ADDENDUM NO. 1

RE: Item #11, April 6, 2016 Letting - NH 0016(88)0, NH 0079(76)58, NH 0212(185)13, PCN 05ML, 05MM, 05MN, Butte, Custer County - Asphalt Concrete Shoulder Repair

ASPHALT CONCRETE SHOULDER REPAIR

STATE OF SOUTH DAKOTA	PROJECT	SHEET	TOTAL SHEETS
	NH 0016(88)0, NH0212(185)13, & NH 0079(76)58	1	17

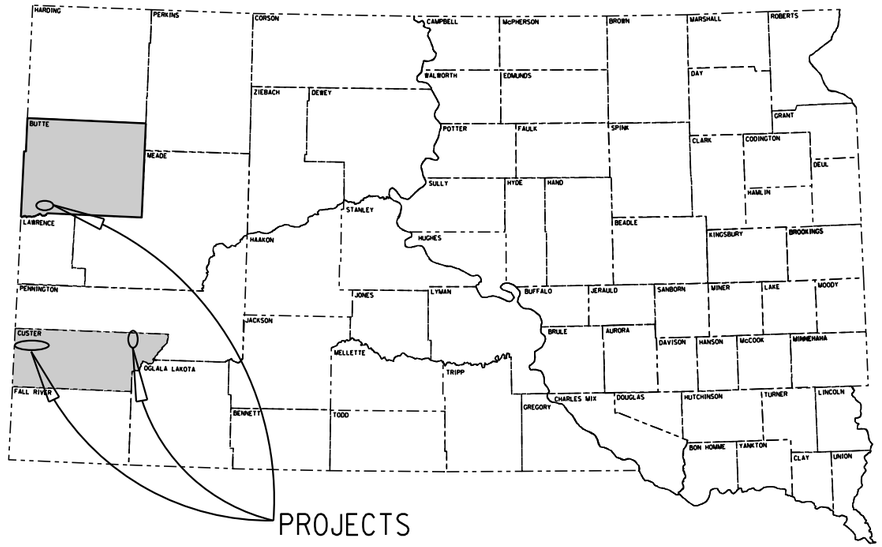
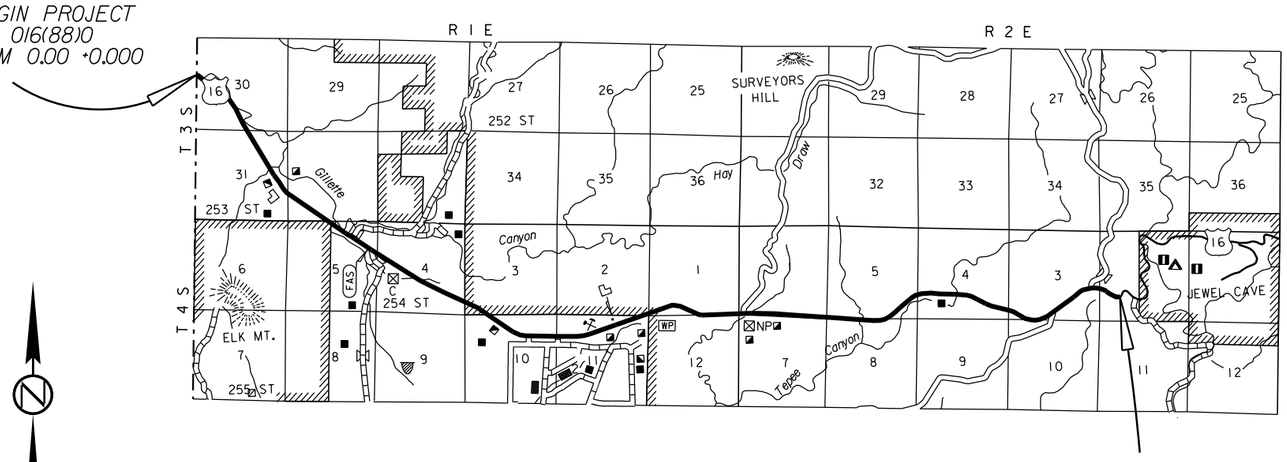
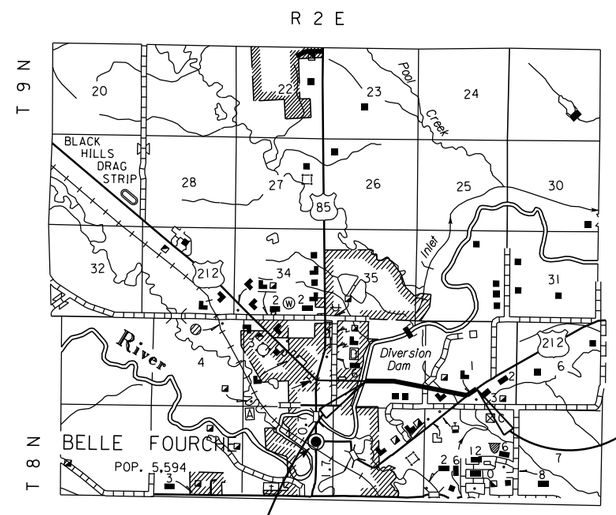
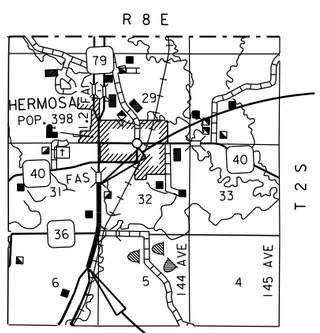
Sheet 1: Revised starting MRM for PCN 05MN from 13.82 + 0.047 to MRM 14.00 + 0.097

BEGIN PROJECT
NH 0212(185)13
MRM 14.00 + 0.097

STATE OF SOUTH DAKOTA	PROJECT	SHEET NO.	TOTAL SHEETS
	NH 0016(88)0, NH 0212(185)13 & NH 0079(76)58	12	17

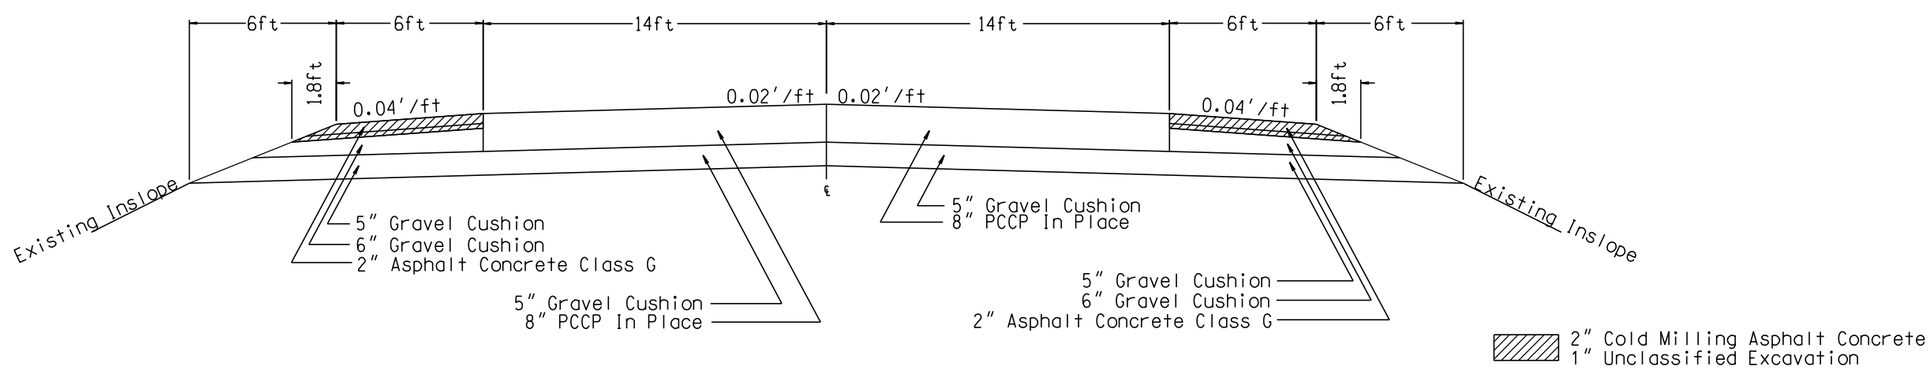
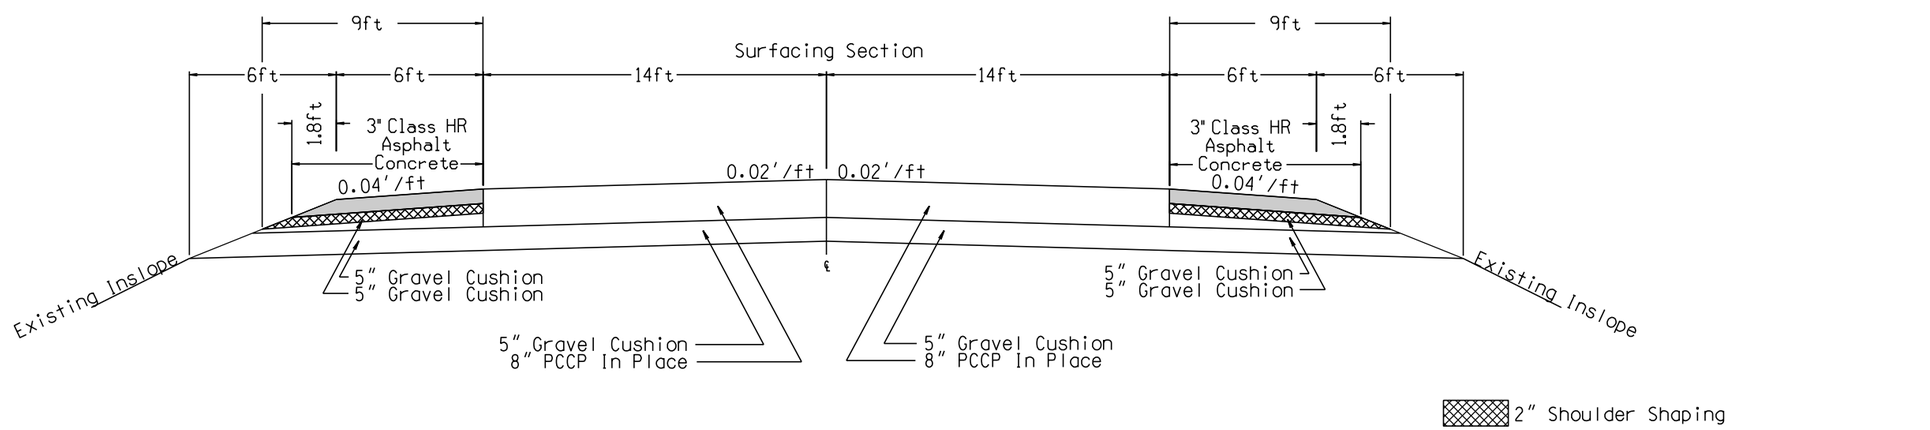
Sheet 12: The beginning MRM for the Typical Section for PCN 05MN was revised.

US Highway 212
MRM 14.00+0.097 to MRM 15.32+0.100
In Place, Cold Milling and Excavation Section
